Morris Goding  
Access Consulting

Westfield Hurstville -  
ELP Extension

**Access Review v2**

9<sup>th</sup> September 2020

Figure 1. Level R2 Main Entrance Linkages

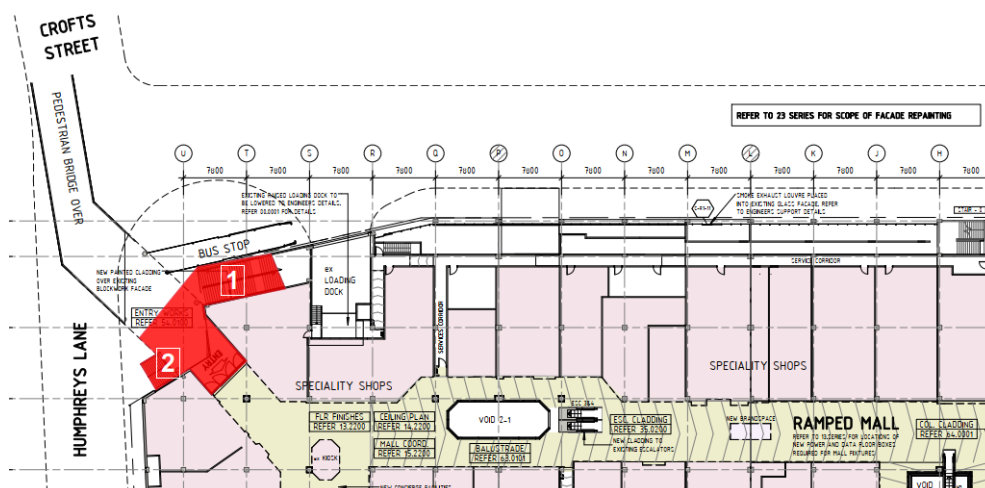
MGAC has audited entrances from allotment boundary on Crofts Avenue, corner with Cross Street and Humphreys Lane. The following have been identified as non-compliances:

- Path of travel is in poor condition.
- Cross falls on the accessible path of travel from boundary to entry doors exceeded 1:40 maximum gradient requirement.
- The entrance at level 2 (street level) does not provide landing prior to the door, which is not in accordance with AS1428.1.
- Existing stairs No.1 and No.2 shown below are not set in accordance with AS1428.1.

- Upgrade paths of travel in poor condition to avoid trip hazards or DDA complaints.
- Floor finishes surfaces are to be in accordance with AS1428.1, Clause 7.2.
- Where cross fall occurs, provide 1:40 max. gradient.
- Entry doors are to provide 1450mm min. Length level landing in front of the doors. Ensuring landing are 1:40 max. gradient. If the existing drop is to be maintained, ensure 1:20 walkway with 1:40 cross falls max. gradients are provided.
- Ensure existing stairs are compliant with AS1428.1. This includes handrails on both sides, slip-resistant and contrasting solid nosings. Handrails extensions, level landings etc.
- Ensure that the minimum illumination levels are meet and compliant with AS1428.2 in particular (entrances, passageways and walkways have a provision of s150 Lux).

Figure 4. Stairs 1 Located on Cross Street that links at L3 to stairs 3.

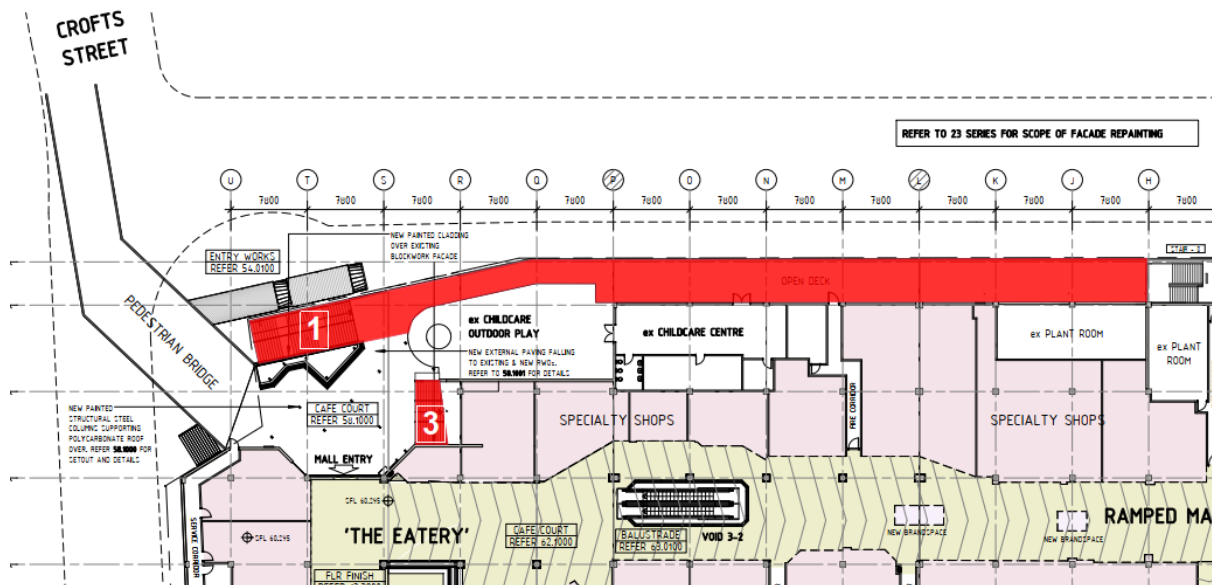
MGAC has audited entrances from allotment boundary on Cross Street. The following have been identified as non-compliances:

- Cross falls on the accessible path of travel from boundary to entry doors exceeded 1:40 maximum gradient requirement.
- Existing stairs No.3 shown in the above floor plan are not set in accordance with AS1428.1.

- Floor finishes surfaces are to be in accordance with AS1428.1, Clause 7.2.
- Where cross fall occurs, provide 1:40 max. gradient.
- Ensure existing stairs are compliant with AS1428.1. This includes handrails on both sides, slip-resistant and contrasting solid nosings. Handrails extensions, level landings etc.
